UNITED STATES PATENT AND TRADEMARK OFFICE

APPLICATION NO.	FILING DATE	FIRST NAMED INVENTOR	ATTORNEY DOCKET NO.	CONFIRMATION NO.
09/847,759	05/02/2001	Mark J. Hall	HANBEV.002RA	6043

Office Action Summary	Application No. 09/847,759	Applicant(s) HALL, MARK J.	
	Examiner Gregory J. Strimbu	Art Unit 3634

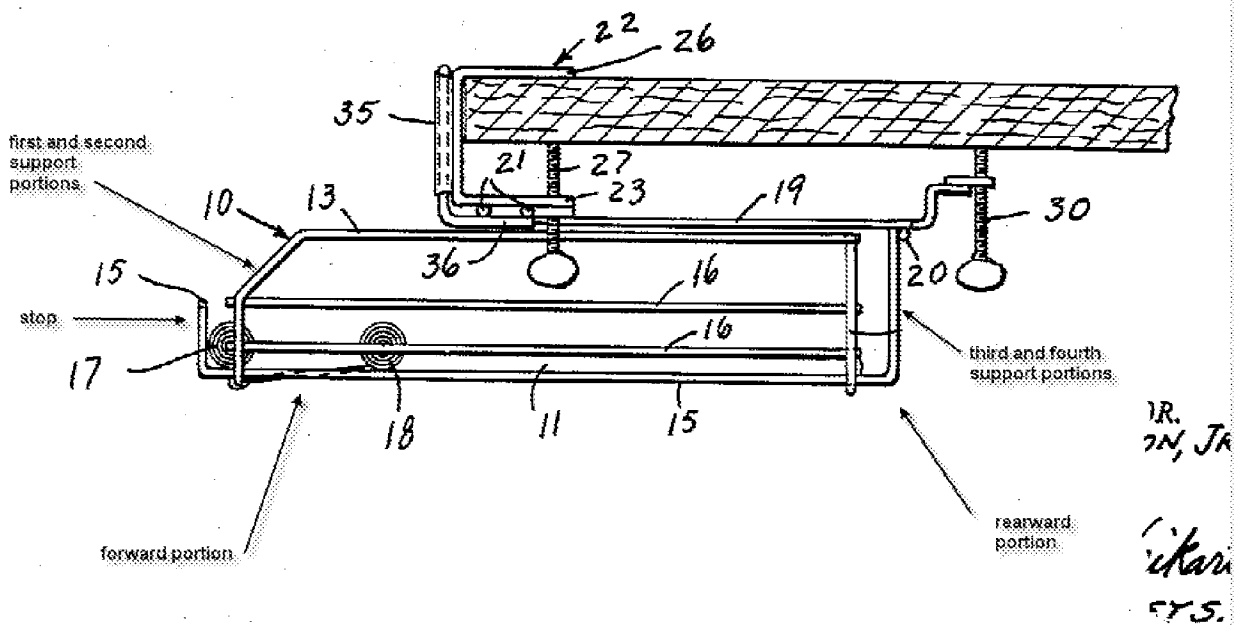
Claims 57, 59 and 61 are rejected under 35 U.S.C. 103(a) as being unpatentable over Dickson in view of Lockwood. Dickson discloses a shelf comprising:

a support assembly having a forward portion (labeled below) and a rearward portion (labeled below), the support assembly defining a support surface (not numbered, but shown in figure 3) configured to support a plurality of cylindrical beverage containers;

a stop (labeled below) disposed at the forward portion of the support assembly;

first and second support portions (labeled below) disposed at the forward portion of the support assembly, the first and second support portions including upper ends, respectively, adapted to be disposed above the plurality of cylindrical beverage containers supported on the support surface;

at least first and second apertures (not numbered, but comprising the apertures for the fasteners 27) disposed adjacent the upper ends of the first and second support

portions, respectively, the first and second apertures being configured to receive fasteners 27 for supporting the forward portion of the support assembly from a structure 32 above the support assembly, the first and second apertures being spaced rearwardly from the stop;

third and fourth support portions (labeled below) disposed at the rearward portion of the support assembly, the third and fourth support portions including upper ends, respectively;

at least a third aperture (not numbered, but shown as the aperture for the fastener 30 in figure 3) disposed adjacent the upper ends of the third and fourth support portions, respectively, the third aperture being configured to receive a fastener 30 for supporting the rearward portion of the support assembly from a shelf above the support assembly; and

wherein the third aperture is spaced from a rearward most portion 20 of the rearward portion of the support assembly such that cylindrical beverage containers can be placed onto the rearward portion of the support assembly when the third aperture is connected to a shelf disposed above the support assembly by fasteners;

a horizontally extending plate 35 (claim 61) having apertures in the plate which receive the wire 36. Dickson is silent concerning a panel and a fourth aperture.

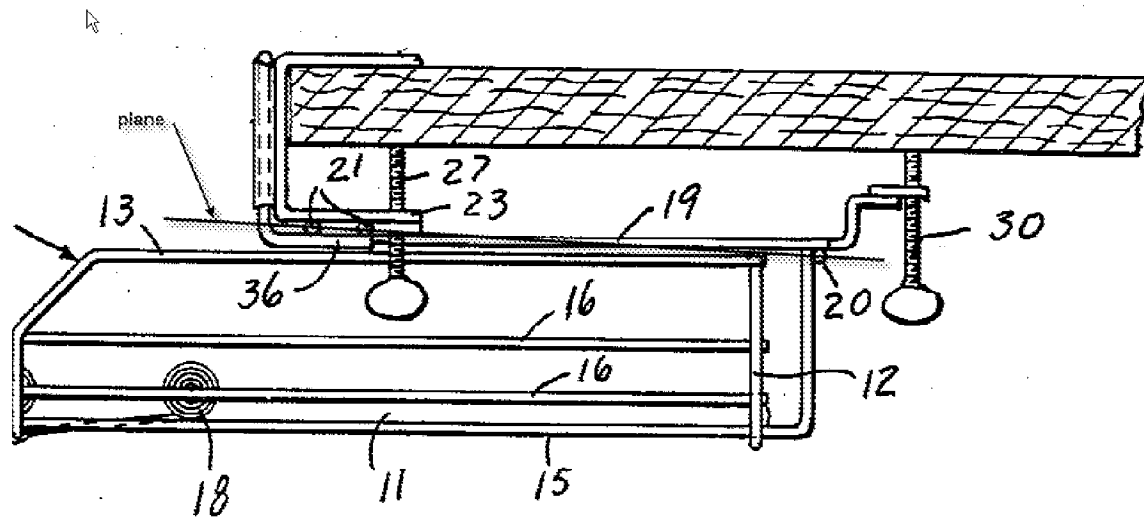
a front member 21 and at least two other members 21, 20 rearwardly spaced from the front member and, together with the front member, defining a first plane and configured to support additional shelving above the first plane;

a framework 15 defining a second plane disposed below the first plane and configured to support a plurality of beverage containers between the first and second planes;

and at least one support (labeled above) connecting at least the front member and the framework;

wherein at least a portion of the framework (labeled above) extends at least forward of a projection of the front member, the projection including with a stop (labeled above) extending in a direction from the second plane toward the first plane; and

Regarding the applicant's comments concerning claim 56, the examiner respectfully disagrees. The rods 20, 21, 21 of Dickson define a plane since each of the rods defines a point and each of said points is in a plane as shown in the reproduction of figure 3 of Dickson below.
